# **Building Code of Australia**

## **Assessment Report**

**Project Address: 8 Forest Road, Warriewood NSW 2102  
– Stage 2**

Client: Warriewood Vale Pty Ltd  
Report Number: 200091.1 (BCA)  
Revision: 01

Figure 1

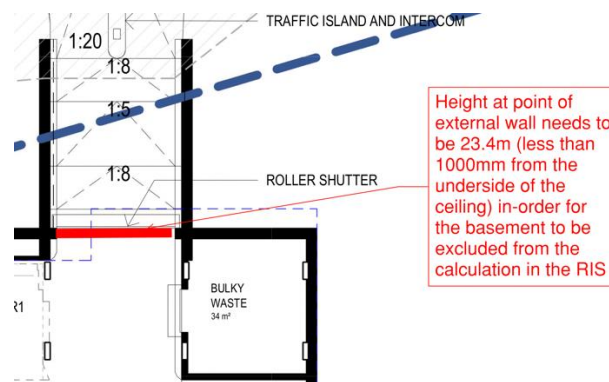
The current design incorporates a driveway entry on the northern elevation which has a finished floor level of 21.4m at the external wall which results in the basement being counted in the RIS which increases the RIS to 4 and triggers the requirements for sprinkler protection throughout the residential portion of the development as per E1.5 of the BCA. In order to maintain a RIS of 3, the finished floor level at the basement entry, (figure 1) needs to be raised to a height of 23.4m, so that the height of the finished floor level, measured at the external wall, is located less than 1000mm from the underside of the basement soffit, as per C1.2 of the BCA.

This report has been prepared on the assumption that the basement carpark entry and external ground level will be adjusted so that the basement is not counted in the Rise in Storeys and the building achieves a RIS of 3. **Design modification required.**

Figure 2

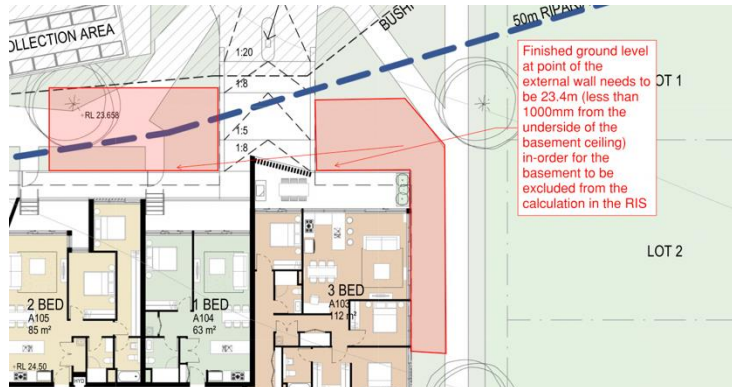
In addition, the external ground level located in the north eastern corner of the building and on either side of the basement carpark entry (figure 2 & 3), also needs to achieve a height of 23.4m at the external

wall (less than 1000mm from the soffit of the basement) in order for the basement carpark storey to be excluded from the calculation in the Rise in Storeys.

Figure 5

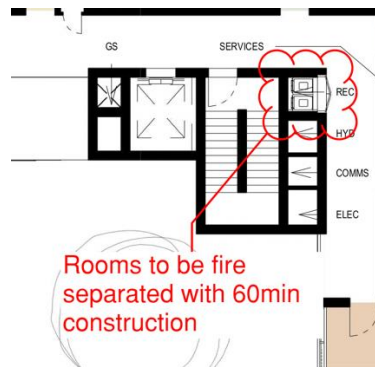
- 5.8. Doorways of SOU's are required to be protected in accordance with C3.11 of the BCA with self-closing -/60/30 fire doorsets.
- 5.9. The proposed garbage / recycling rooms opening into the residential lobbies are required to be separated from the remainder of the building with 60min construction and self-closing -/60/30 fire doorsets as per C3.11(b).
